Landscape and Visual Impact – Addendum Report

Proposed Molong BESS:

FOR: StorEnergy 3 Pty Limited

12 May 2026

Figure 1 Temporary Laydown Areas

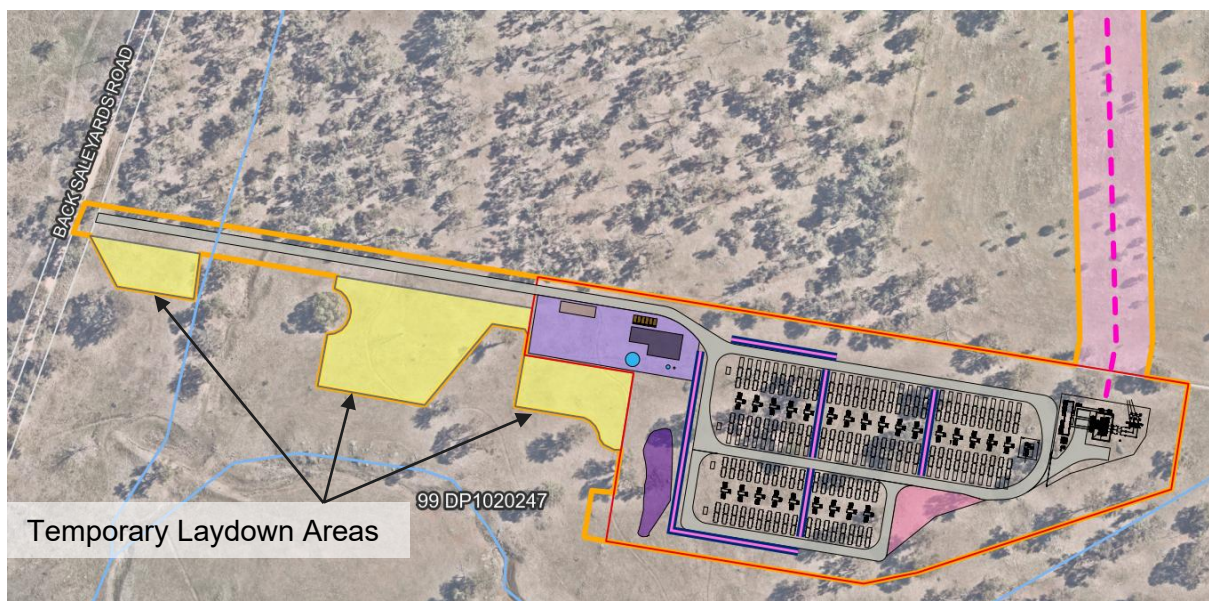
The temporary laydown areas associated with the Project would incorporate stockpiled materials, machinery, equipment and a temporary site office. Figure 1 shows the location of the temporary laydown areas in relation to the Project footprint.

The temporary laydown areas or their location was not specifically identified in the LVIA. However, the original assessment covered the key components such as stockpiled materials, machinery and equipment. On review of the plan shown in Figure 1, their location was found to be appropriate given their proximity to the Project site and would not give rise to adverse visual impact beyond what was identified in the original assessment.

For this reason, there would be **no change** to the original assessment result due to the temporary laydown areas.

Figure 2 Operations and Maintenance (O&M) Building

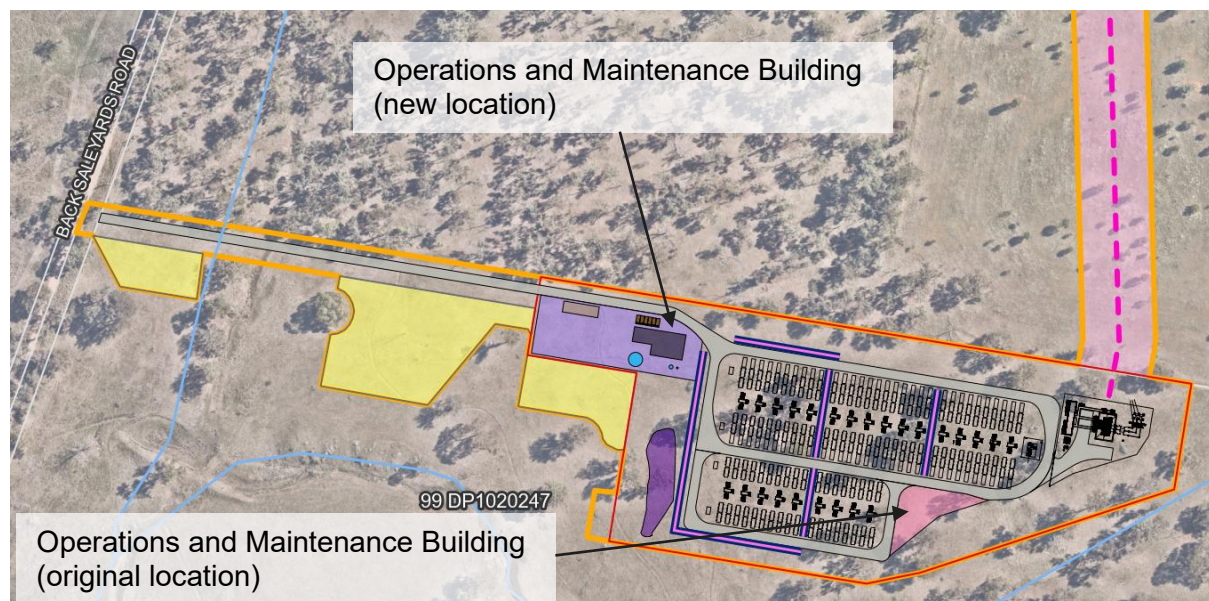
The proposed location for the Operations and Maintenance (O&M) building has moved from the southeastern corner of the Project site to the northwestern section as shown in Figure 2.

The O&M building is expected to be similar in appearance to a farm shed, with external colours to match those of the proposed noise walls or otherwise chosen to blend appropriately with the surrounding landscape.

For this reason, there would be **no change** to the original visual impact assessment results due to the relocation of the O&M building.

Figure 3 Overhead Transmission Line Easement

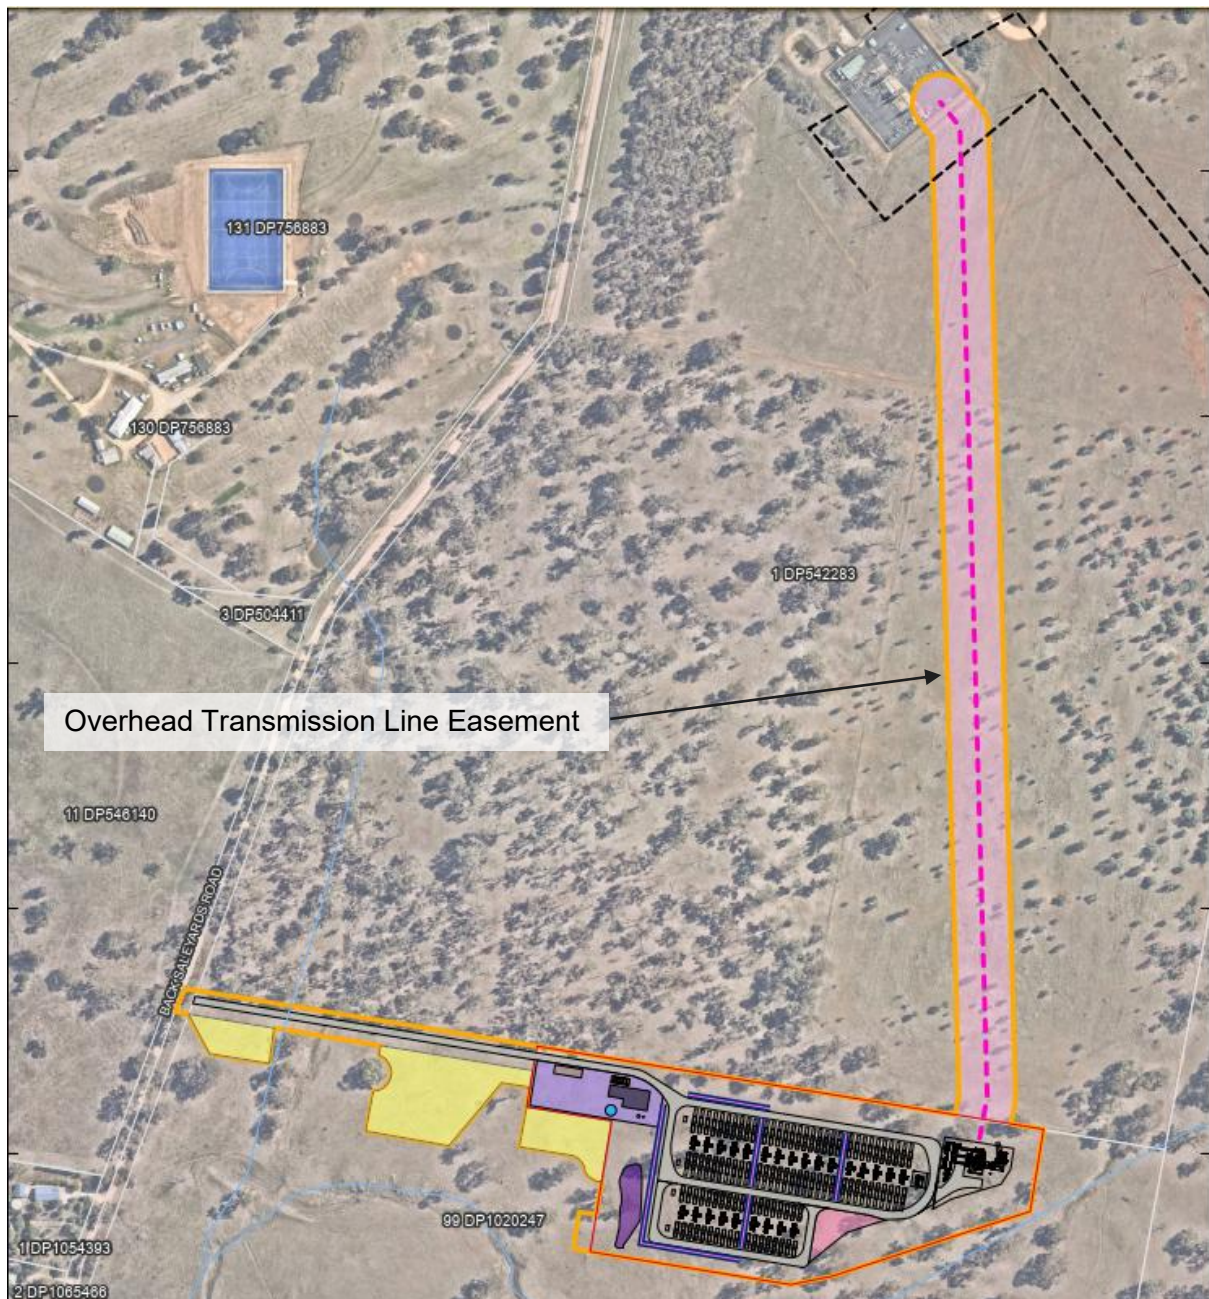
- A total of six transmission poles (of monopole design), reduced from eight.
- These would be distributed equally along the originally proposed transmission line easement, from the Project site to the existing electrical substation to the north.
- A height of 30 m each for all six poles, increased from 18 m.

In the photomontage prepared for Viewpoint 4 – Marsden Street #2, two of the original eight transmission poles were marginally visible above existing vegetation. The other six were completely concealed from view by the vegetation. As a result of this project refinement, the additional pole height is expected to result in slightly increased visual prominence of two poles closest to the BESS site with no increase in visibility of the others along the transmission line route.

In the photomontage prepared for Viewpoint 5 – Back Saleyards Road #1, all eight transmission poles were concealed from view by existing vegetation. The additional pole height is expected to potentially result in the increased visual prominence of two poles with no change in visibility of the others.

Given the reasons above, the change in pole design is expected to potentially result in the increased visual prominence of a small proportion of poles from Viewpoints 4 and 5. In the photomontages, the transmission poles constitute a minor, thin vertical element compared to the visual bulk of the rest of the Project, such as the noise walls. The increased height would therefore not cause a significant change to the level of visual impact of the Project from Viewpoints 4 and 5.

For this reason, there would be **no change** to the original visual impact assessment results due to the increased height of the transmission poles.
